Wisconsin Department of Transportation

Proposal #01: 4650-08-71, WISC 2017 623
City of Kaukauna, Delanglade Street
Lawe Street – IH 41
STH 55
Outagamie County

This is Addendum No. 01, which provides for the following:

Addendum No.01
ID 4650-08-71
Revised Sheet 52
December 4, 2017

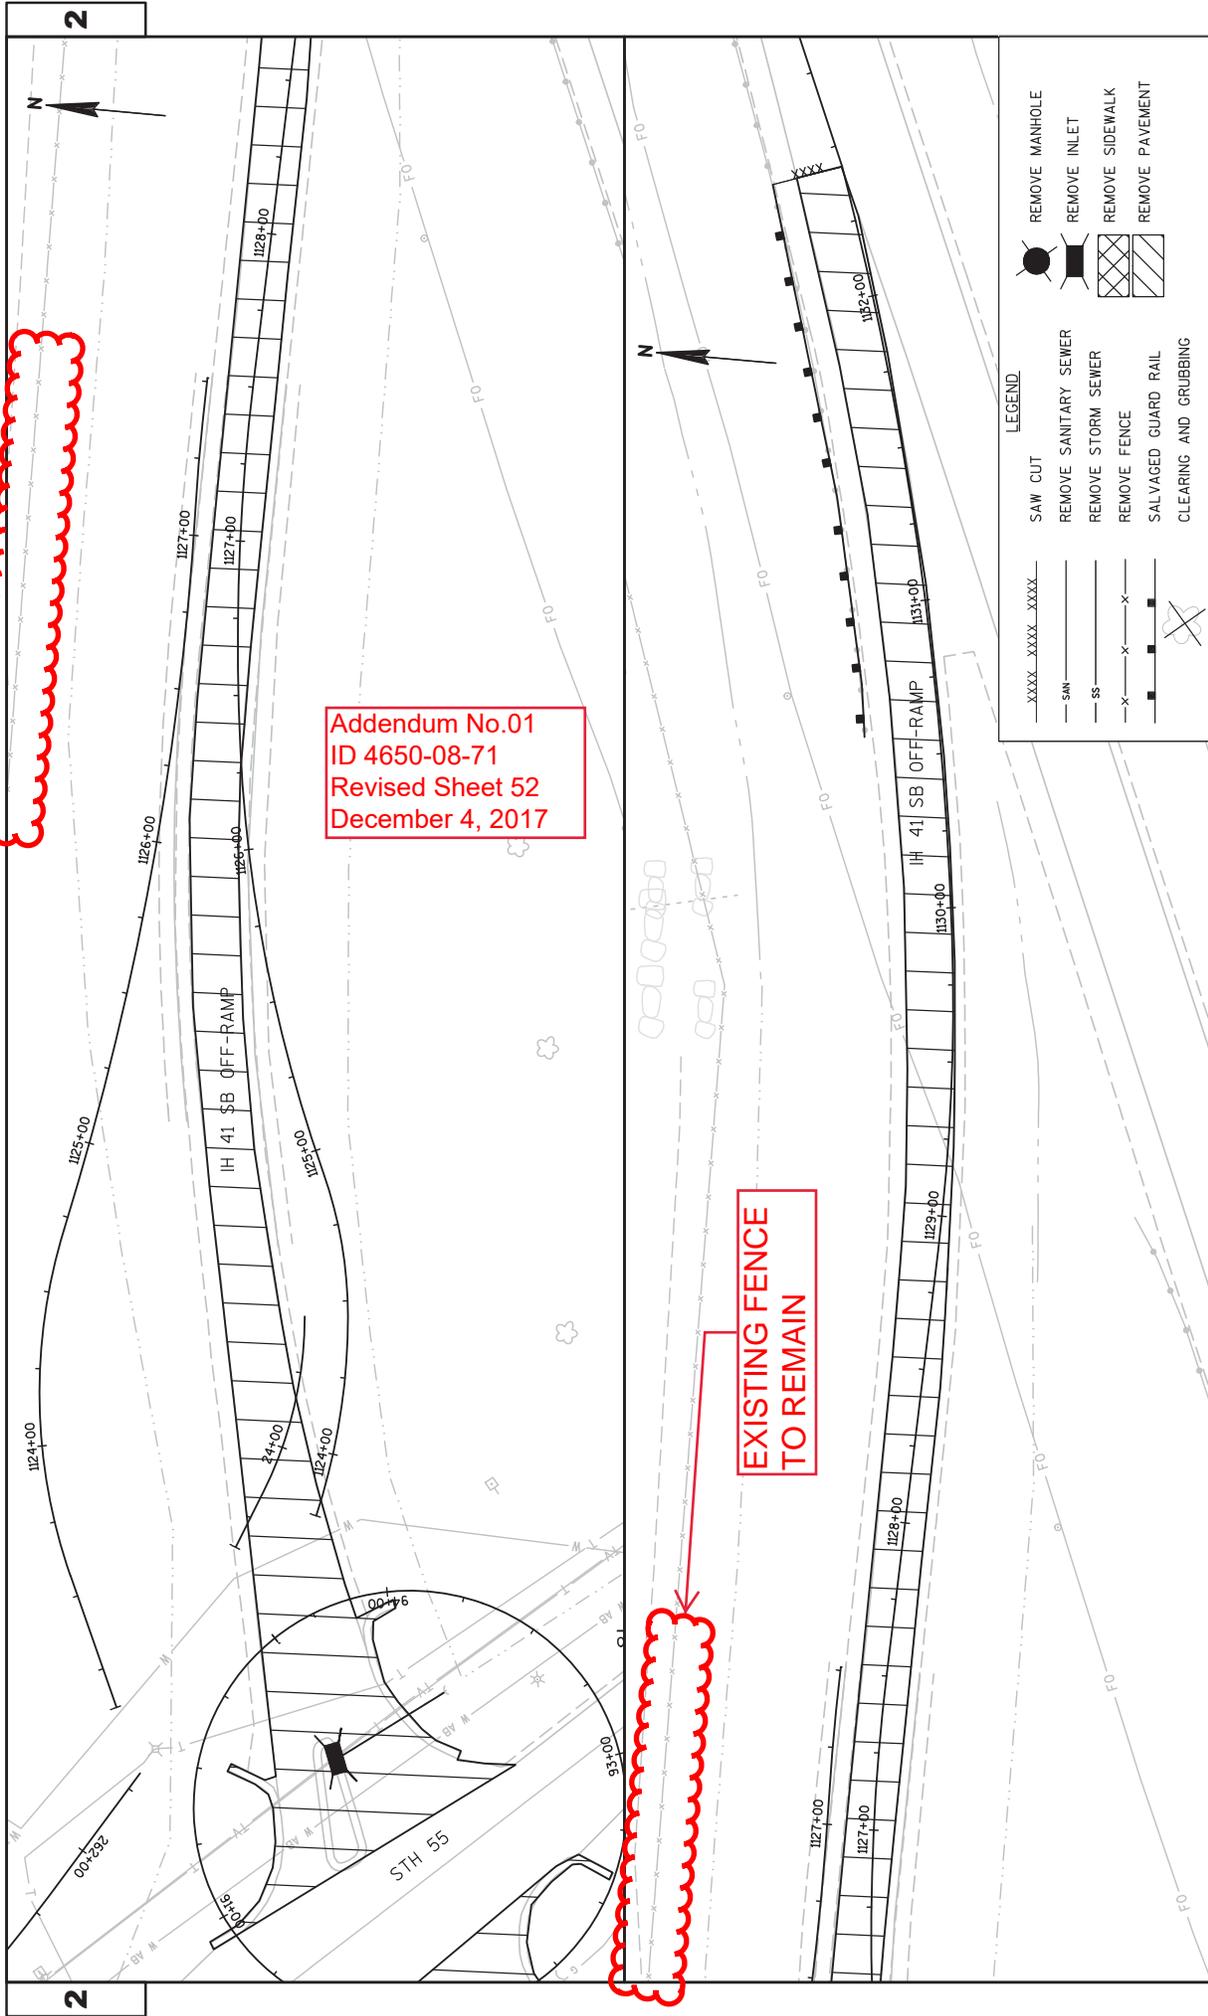
Revised Plan Sheets	
Plan Sheet	Plan Sheet Title (brief description of changes to sheet)
52	Fence removal limits along IH-41 SB off-ramp revised.
53	Fence removal limits along IH-41 SB on-ramp revised.
54	Fence removal limits along IH-41 SB on-ramp revised.
66	Gertrude Street concrete pavement thickness changed from 9-in to 8-in.
78	Gertrude Street concrete pavement thickness changed from 9-in to 8-in.
79	IH 41 HMA shoulder changed from 3.5-in to 6.5-in
80	IH 41 HMA shoulder changed from 3.5-in to 6.5-in
83	IH 41 HMA shoulder changed from 3.5-in to 6.5-in
84	IH 41 HMA shoulder changed from 3.5-in to 6.5-in
159	Note #5 added concerning conduit depth beneath railroad tracks and conduit location revised.
234	Removing Fence quantity table revised.
240	Concrete Pavement quantity table revised.
243	Asphaltic Items quantity table revised.
248	Fence Chain Link quantity table revised.
294	Traffic Signal Conduit quantity table revised.
